Re: *In the Matter of C&H Hog Farms* - Docket No. 18-001-P

Motion to Intervene and Request for Hearing of Buffalo River  
Watershed Alliance, Arkansas Canoe Club, Gordon Watkins and  
Marti Olesen

MOTION TO INTERVENE AND REQUEST FOR HEARING  
BY BRWA-ACC INTERVENORS,  
AND  
MOTION TO DISMISS C&H HOG FARMS'S REQUEST FOR HEARING

**Comment B5 - This permit should be denied because the application buffers for fields 7 and 3 do not sufficiently consider activity areas of nearby high school**

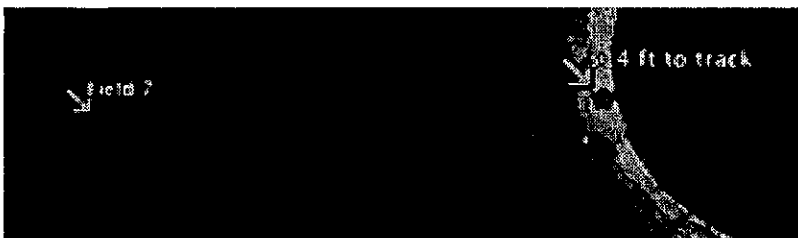
The fields appear to be outside the 500 ft range of buildings as Reg 5 requires, however they are well within 400 feet of school property and the athletic track where children will be present.

Field 7 distance is 314 ft.

Field 3 distance is 389 ft

The seasonality and weather in which children are likely to be active corresponds with ideal conditions for spreading. ADEQ has the ability to apply conditions to a permit for unique situations like this where the health of children are a consideration.

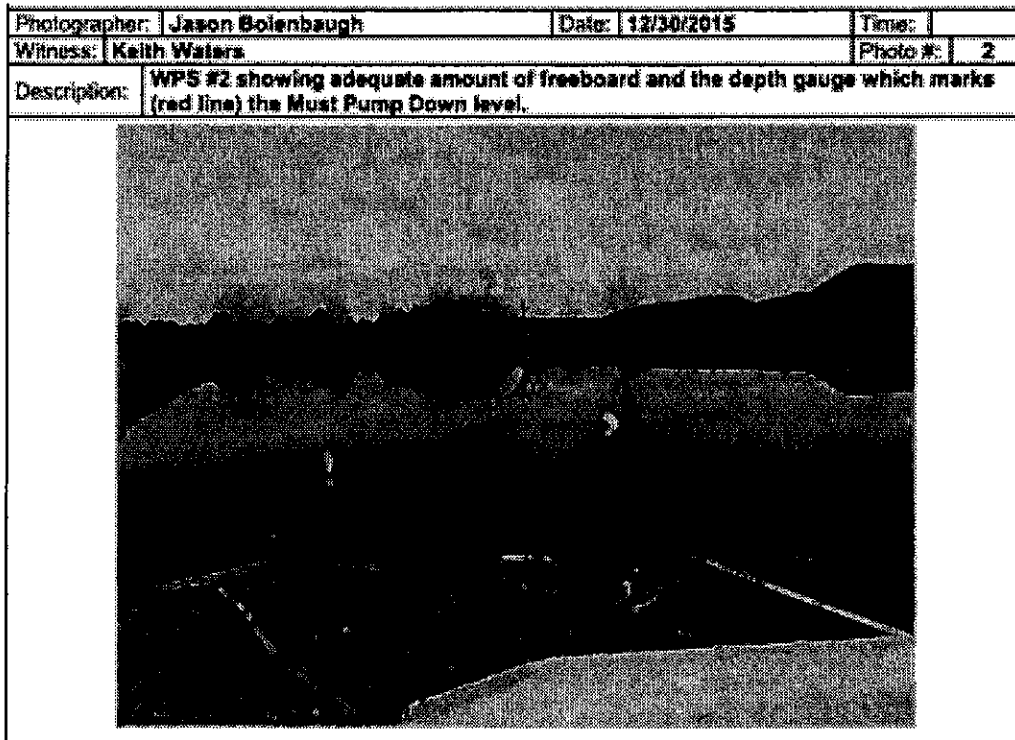
***“If the embankment of Pond 2 were overtopped due to unusual weather or poor management, there would be erosion of the embankment with possible catastrophic failure. The waste storage ponds are built on the side of a hill with 10% slope, making stability of the embankment structure critical.”***

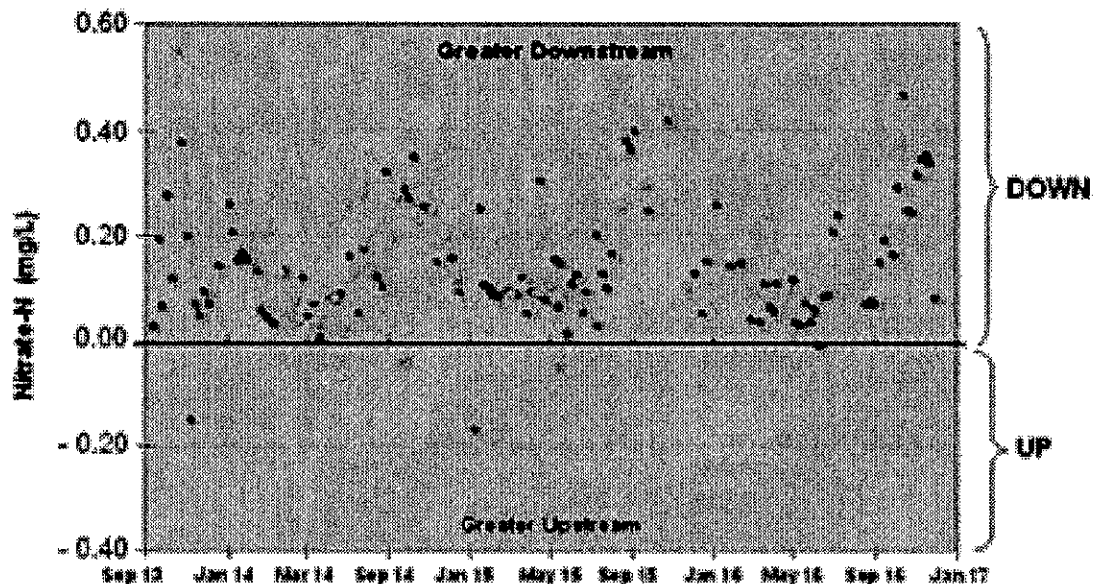
Nitrates are being measured by the *Big Creek Research and Extension Team* (BCRET) of the *University of Arkansas Division of Agriculture* both upstream and downstream of the facility and nearby spreading fields Figure 1.

***"Nitrate concentrations at the downstream site have been consistently higher than at the upstream site on nearly all BCRET sampling dates since swine waste applications from the C&H CAFO began (BCRET 2014a-d, 2015a-d, 2016a-d) (Figure 1). During January – November 2016, for example, paired upstream/downstream data showed that nitrate was substantially lower at the upstream station than at the downstream station on 40 of 41 sampling dates; concentrations were comparable on the remaining one date. Elevated nitrate levels near swine CAFOs are commonly used as an indicator of swine waste discharge; the wastes initially are high in ammonia, but over short distances during transport the ammonia is oxidized to nitrate (Dewi et al. 1994). Nitrate levels at the downstream site typically have been two- to three-fold higher than at the upstream site; sometimes the difference has been as high as 25-fold"***

**Figure 3: Dissolved Oxygen data for Big Creek (BUFT06) during August of 2015. (Source: USGS)**

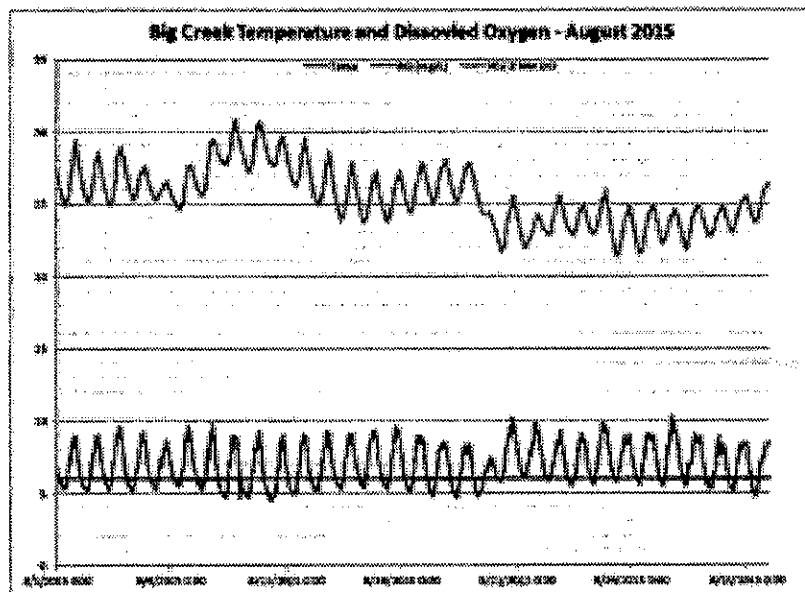
***"NPS has also been monitoring the United States Geological Survey (USGS) sites collecting dissolved oxygen data on tributaries to the Buffalo River. Two of these sites have chronically been below the allowable limits in Regulation 2.505. These are Bear Creek near Silver Hill (USGS Site 07056515) (ADEQ site- BUFT12) (Figure 2) and Big Creek at Carver (USGS Site 07055814) (ADEQ site- BUFT06) (Figure 3).***

***These streams have had minimum dissolved oxygen values of 3.9 and 4.5 mg/L, respectively, well below the standards.***
